**ROBERT L. STAEHLE
153 JAXINE DRIVE
ALTADENA, CALIFORNIA 91001**

2014 January 21

Re: Comments on *Devil's Gate Reservoir Sediment Removal and Management Project Draft Environmental Impact Report (DEIR)*, State Clearinghouse No. 2011091084, October 2013.

Above: Prior project sign from 2013 November 16 (Lori Paul photo.)

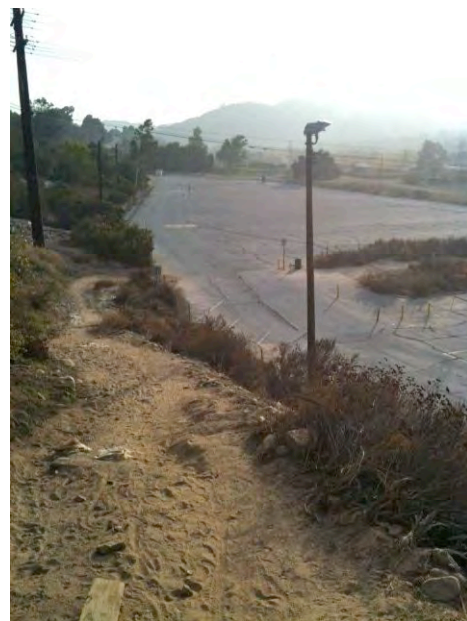
A sign near the bottom of the trail that leads down from the Windsor/Ventura parking area, photographed on 2013 November 16 (see “Devil’s Gate Dam Interim Measures 2013” sign in photo on next page), refers to a project in which “Public Works will remove up to 5,000 cubic yards of sediment...to again be temporarily placed at Johnson Field,” (which is within the Park) and where “The green waste will be hauled to Scholl Canyon Landfill at a rate of no more than 10 trucks per day to avoid impacts to the neighborhood along the haul route on Windsor Avenue.” Therefore, this sign clearly does not refer to the proposed Project described in the DEIR to which this set of comments is addressed. On November 16, well into the comment period, there was no sign nearby describing or giving notice of said Project or DEIR.

Why were prominent signs not placed at sites of other signs frequently seen by Park visitors describing the proposed Project scope, DEIR, and opportunity to comment, for the duration of the comment period? Poor as it was, the “Devil’s Gate Dam Interim Measures 2013” sign photographed 2013/11/16 near the bottom of the trail that leads down from the Windsor/Ventura parking area provided a map and summary description of an earlier project to remove only 5,000 cubic yards of sediment and green waste. Why was it possible to place a sign describing such a small project, with a map included, and yet a descriptive sign could not be placed at the same location, and elsewhere, for the entire comment period, for this Project proposed to be as much as 800 times larger in terms of the volume of sediment removed?

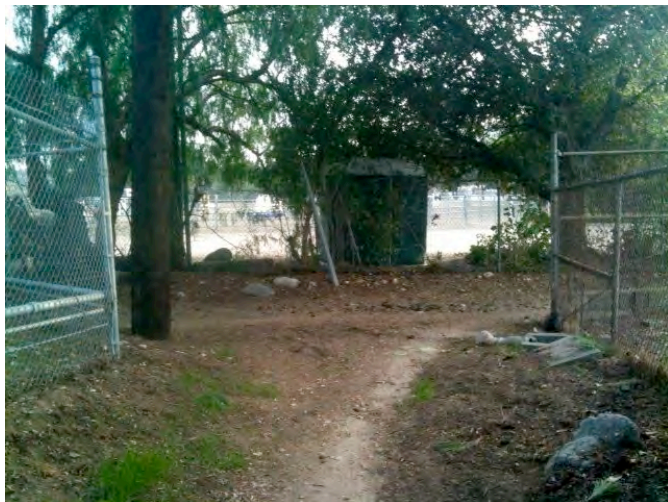
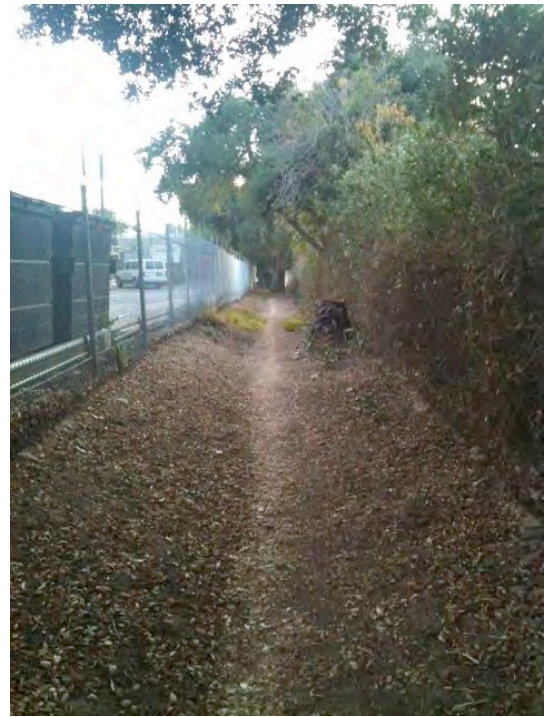
3. a, b, c, d, e, f, g, h, i, j, k, l, m, n: Descent (a, b, c, d) from east to intersection of the trail that crosses the center of the JPL east parking lot with the entering-JPL traffic lane on the east side of the parking lot (e, f, g), and the exiting-JPL traffic lane on the west side of the parking lot (h, i, j, k, l) and ~100 feet west of there (m, n). No Project or DEIR sign. 2014 January 10

5. a, b, c, d: The above trail, where it enters the open area of the Park from between the fence on one side delineating NASA/JPL property and the fence on the other side of this trail delineating the area used by Rose Bowl Riders. No Project or DEIR sign. 2014 January 10

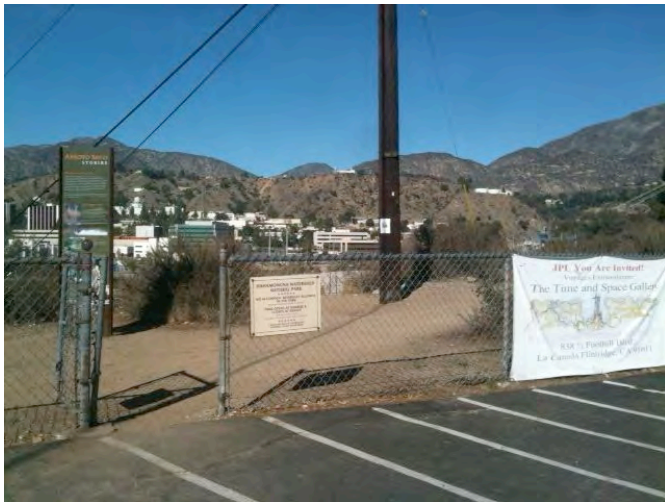
4. a, b, c, d, e, f: The trail near JPL's South Gate, where it leaves the public road to enter the Park from between JPL's south and west corner and the Los Angeles County Fire Department Camp 2 Air Attack installation. No Project or DEIR sign. 2014 January 10

7. a, b, c: The top of the trail that descends from the middle of the west edge of the same parking area down toward the middle of the Park. No Project or DEIR sign. 2014 January 20

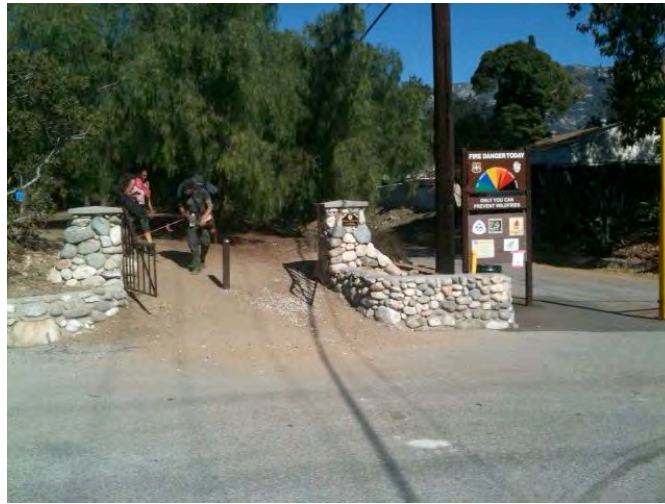
6. a, b: The parking area on the east side of the Park located along N Windsor Avenue between W. Mountain View Street and Ventura Street. No Project or DEIR sign. 2014 January 20
